ATTACHMENT 1

PROPOSED OPERATING LICENSE AMENDMENT

ATTACHMENT 3

## DISCUSSION OF PROPOSED TECHNICAL SPECIFICATION CHANGES

**Figure 5.1-1**  
**Map Defining Unrestricted Areas for Radioactive Gaseous and Liquid Effluents**

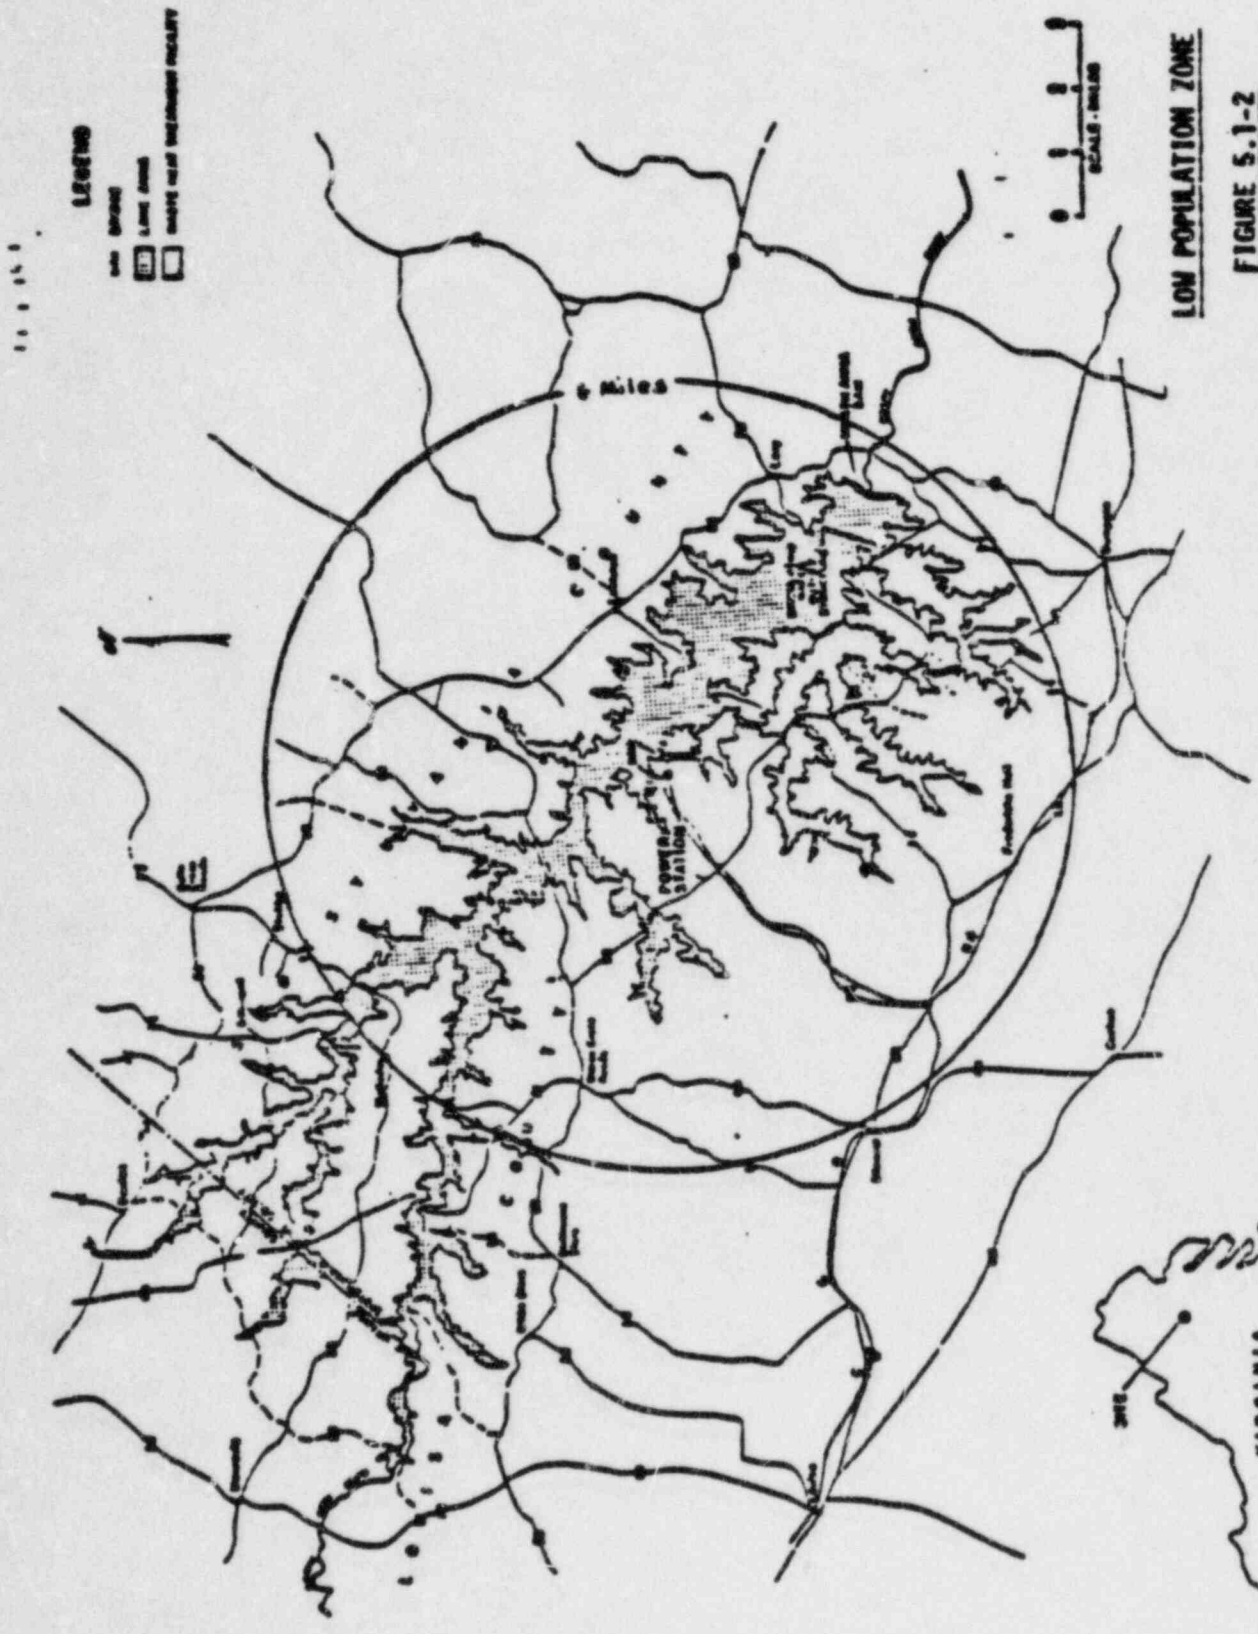
The proposed change to North Anna 1 and 2 Technical Specifications Figure 5.1-1 should be revised to include the location of the Met. Tower. The location of the Met. Tower was inadvertently left out of our RETS submittals.

**FIGURE 5.1-2**

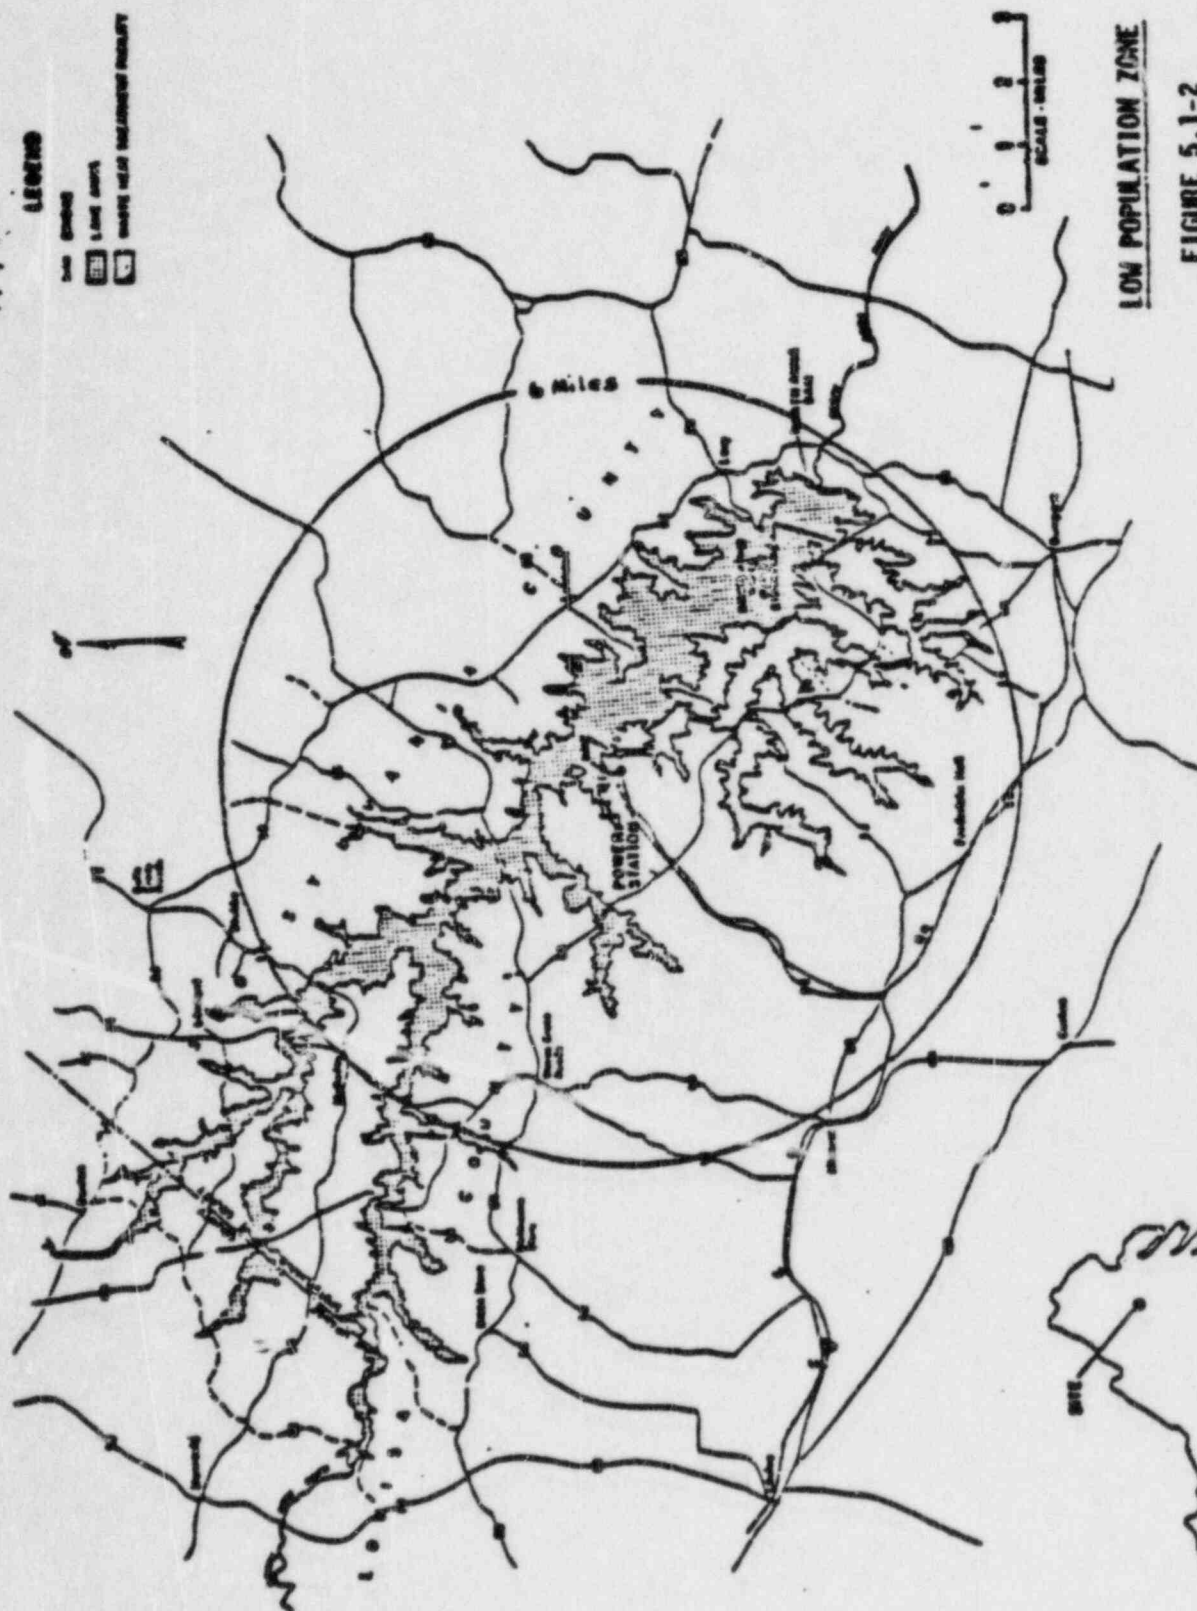
The proposed change to North Anna 1 and 2 Technical Specifications 5.1.2 is to indicate that the low population zone is shown in Figure 5.1-2 instead of Figure 5.1-1. Amendment Nos. 48 and 31, for North Anna 1 and 2, respectively, deleted Figure 5.1-2. Figure 5.1-2 should be re-inserted into the Technical Specifications and so indicated in Technical Specification 5.1.2.
